LINOTYPE IMPROVEMENT INFORMATION SHEET

NO. 261

FIRST ELEVATOR JAW DUPLEX RAIL BANKING PLATE

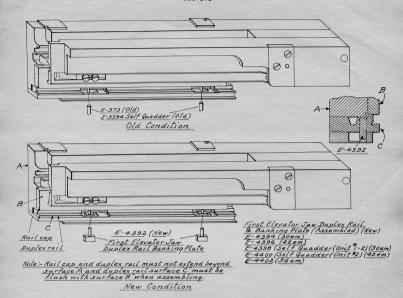
A change from a round pin bank, in the First Elevator Jaw Duplex Rail, to a rectangular banking plate has been made, thereby eliminating wear and providing a better locating surface for the duplex rail.

Can be applied to outstanding models by substituting new First Elevator Jaw Duplex Rail (Assembled) as part numbers indicate.
